Addendum No. 03

SUBJECT: Willamette River: Stormwater Source Control Improvements Project
Lower Columbia River, Northeast Portland, Stadium Freeway
Multnomah
Grading, Drainage, Paving, Signing, Illumination, and Roadside Development
(Bids Closing April 30, 2026)

1. Plan sheets BA03, BA04, BA08, C201, C581, ES01, FA201, FB201, GA201, HA201, HA401A, HB202, PA201, S02, TA201 are replaced with revised plan sheets BA03, BA04, BA08, C201, C581, ES01, FA201, FB201, GA201, HA201, HA401A, HB202, PA201, S02, TA201.

GENERAL CONSTRUCTION SHEET NO. C201

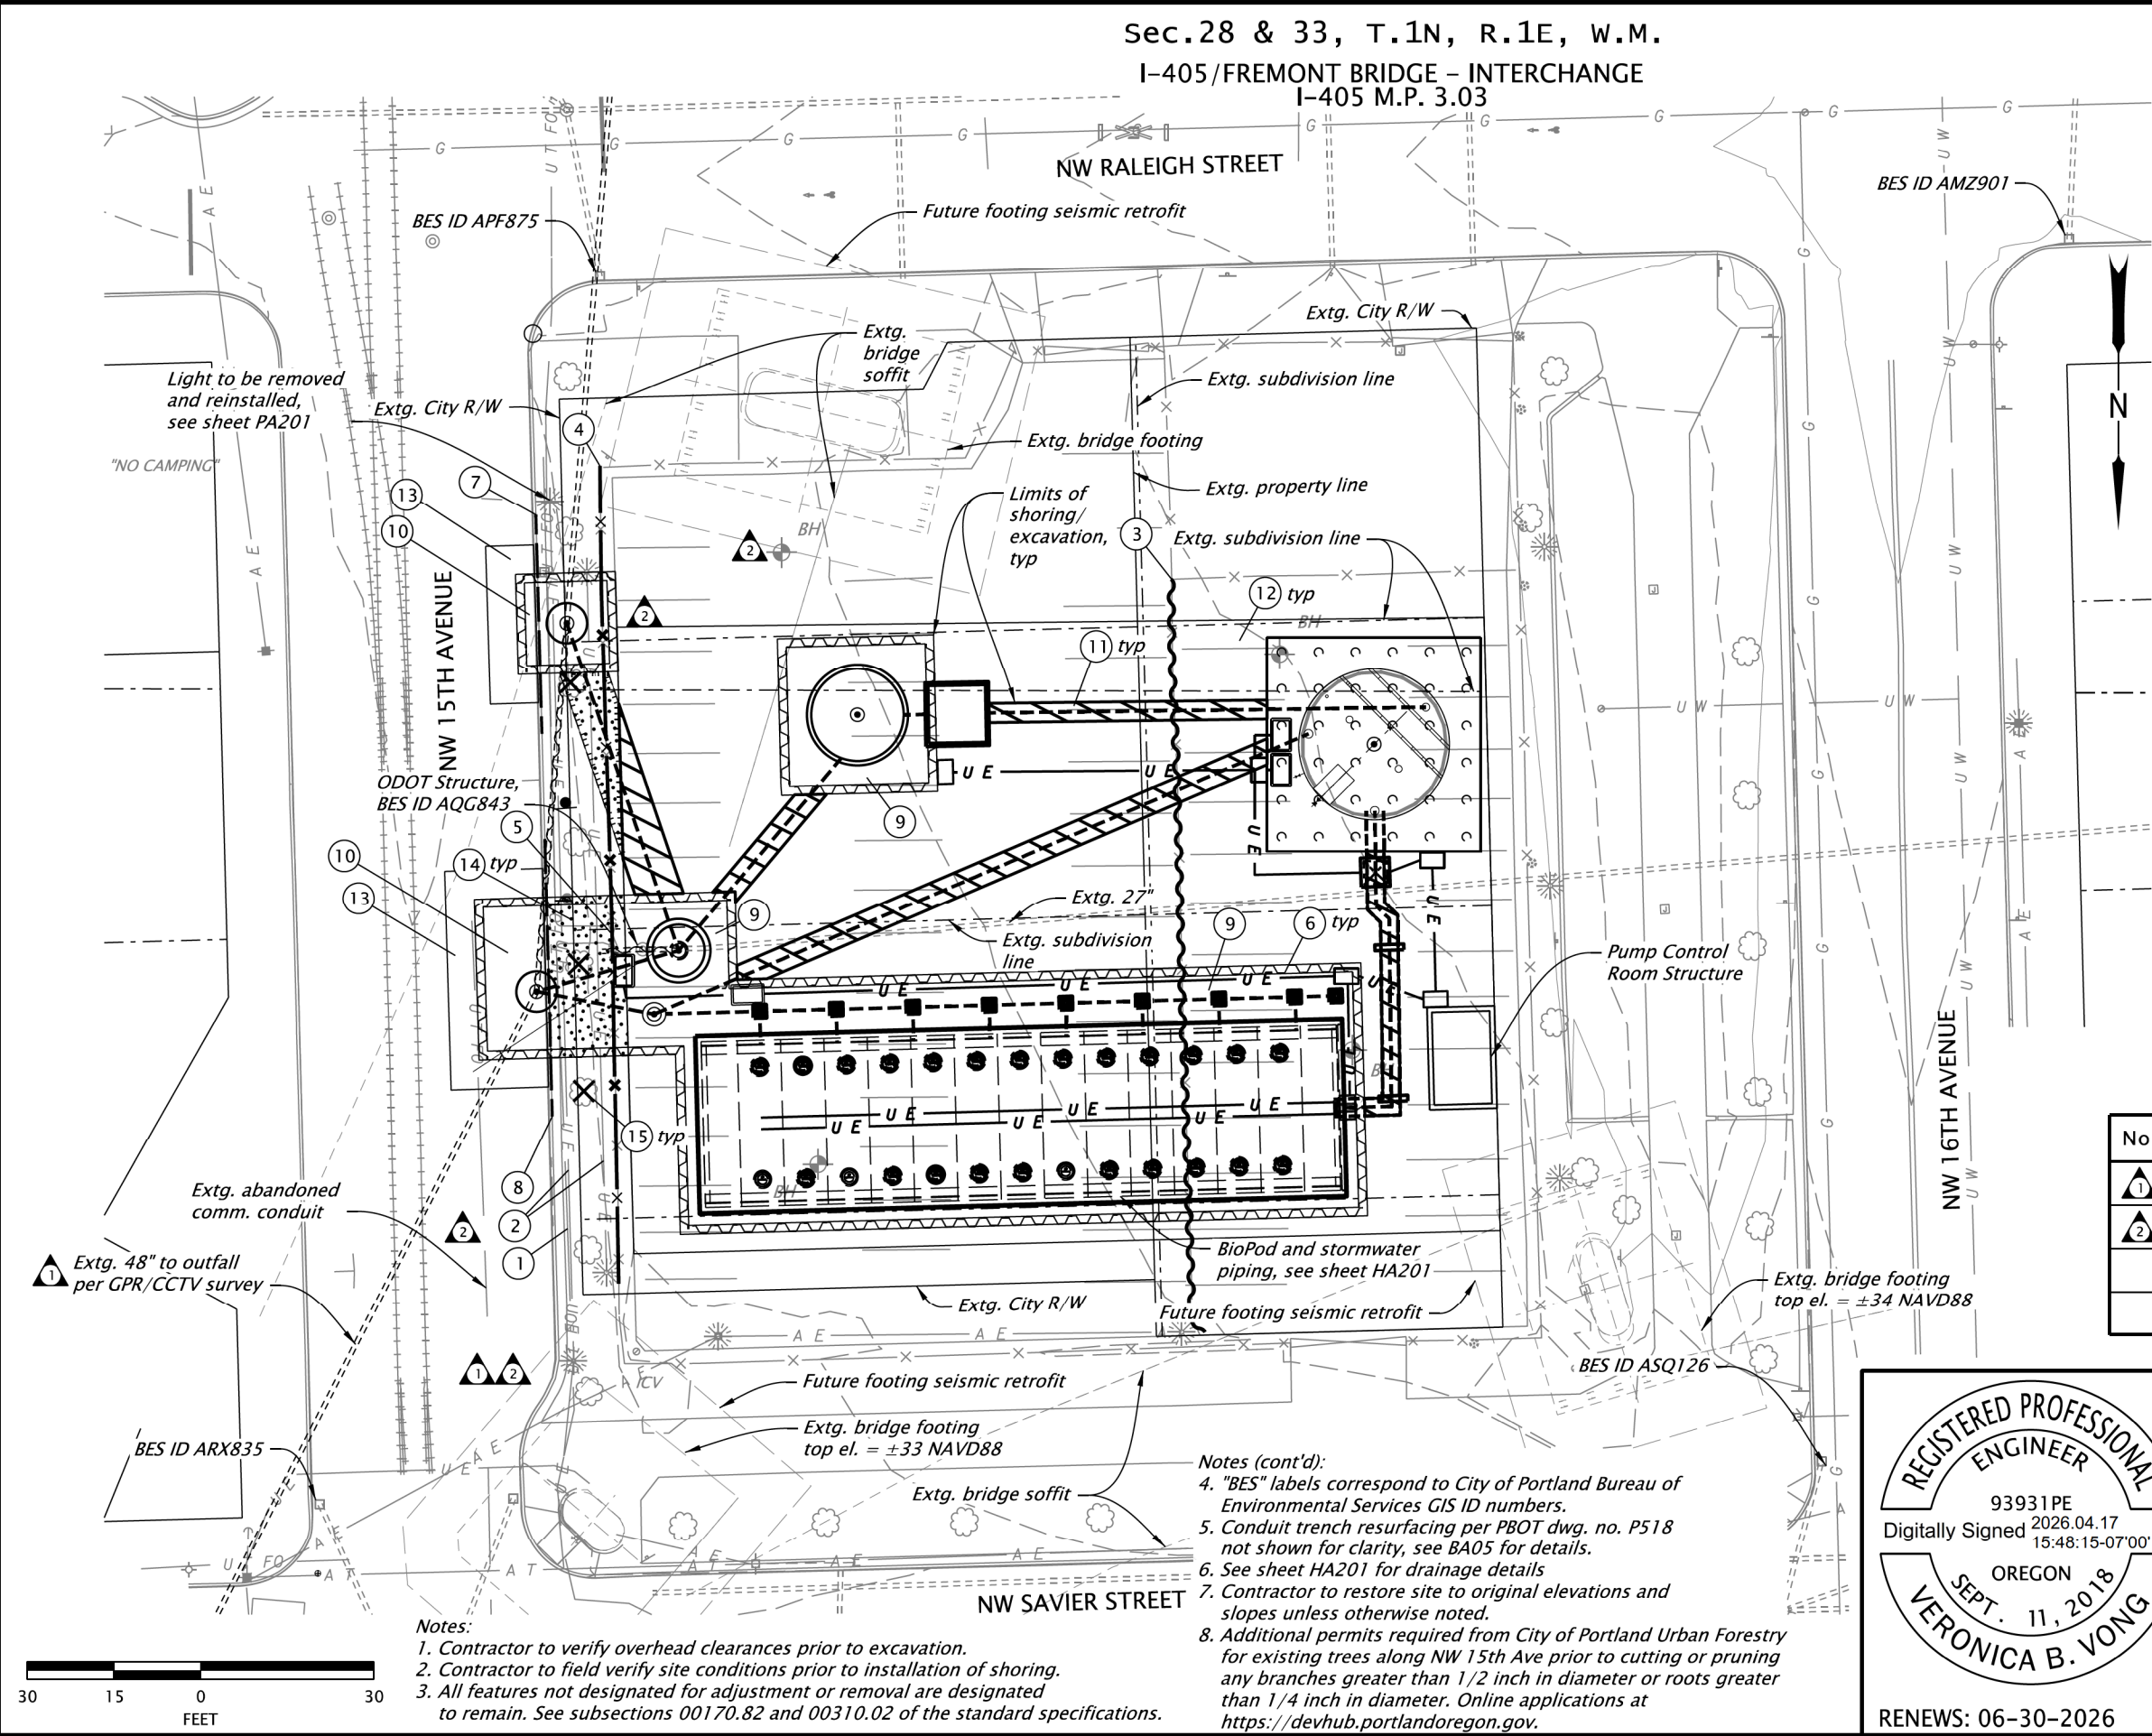
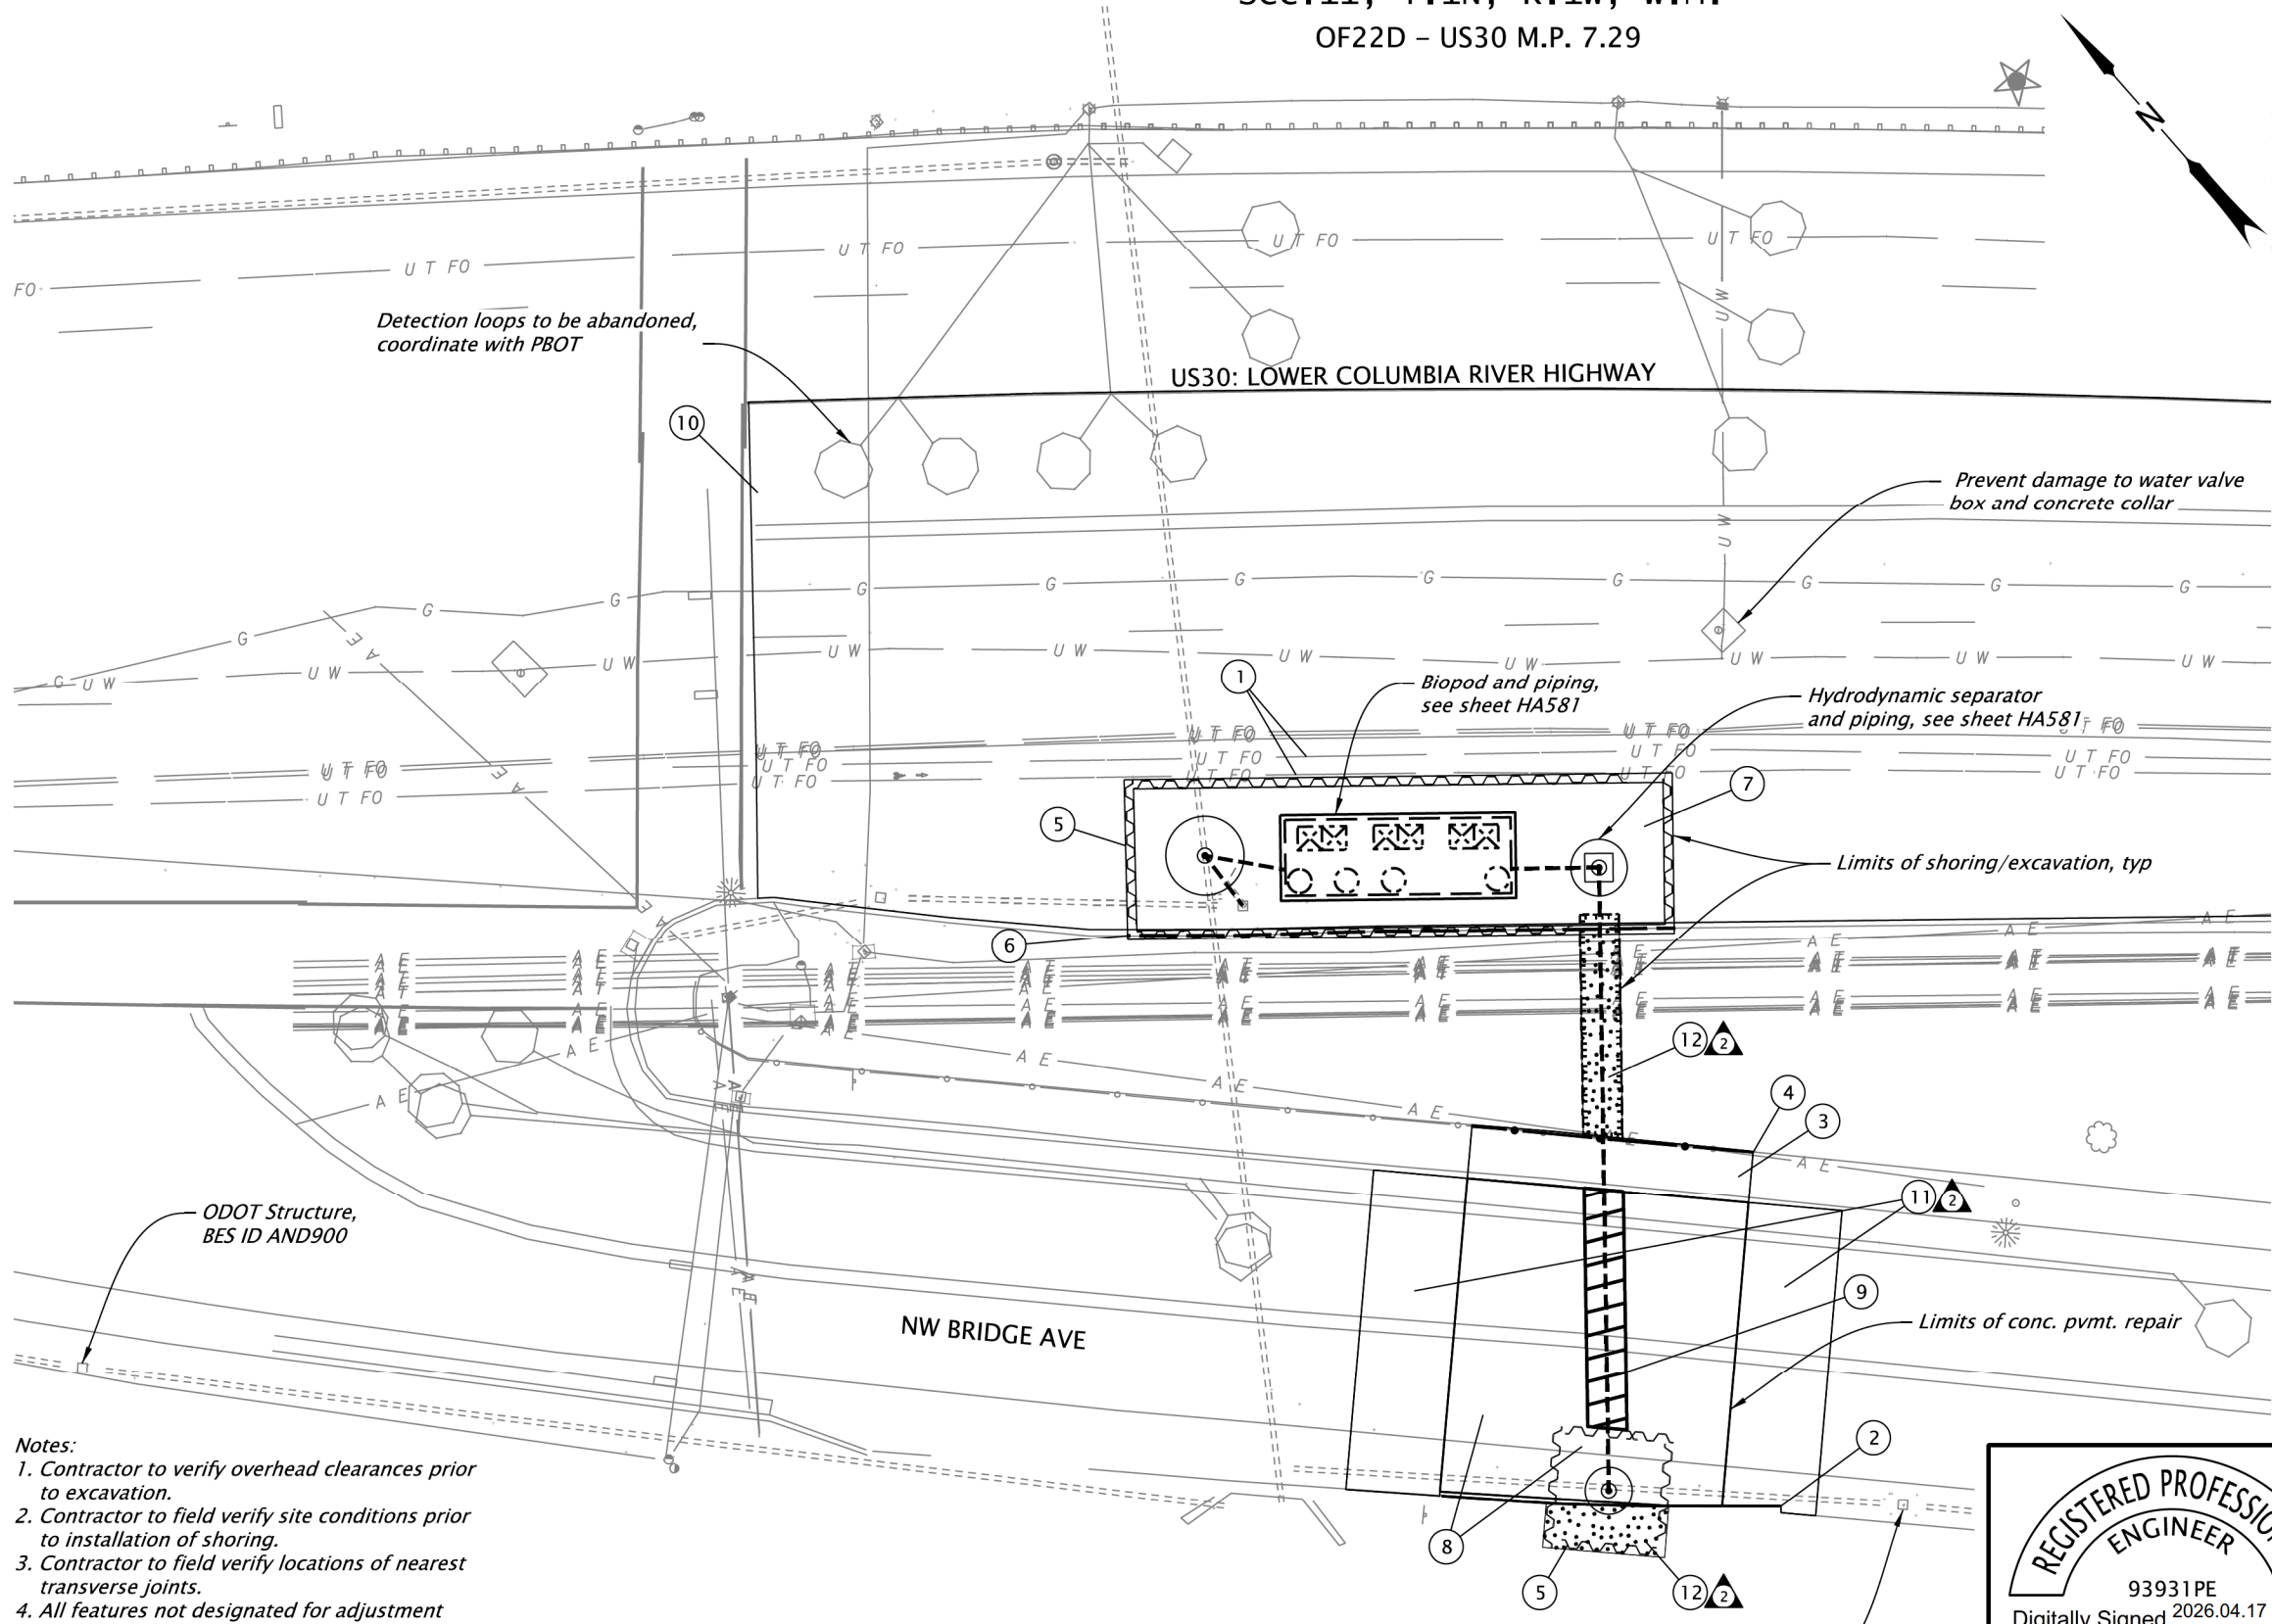
No.	DATE	REVISIONS	BY
1	04-10-26	Adjusted outfall pipe diameters to be consistent with surveys and HA sheets	A.P.J.
2	04-16-26	Removed 42" extg. storm sewer pipe and leaders	A.P.J.
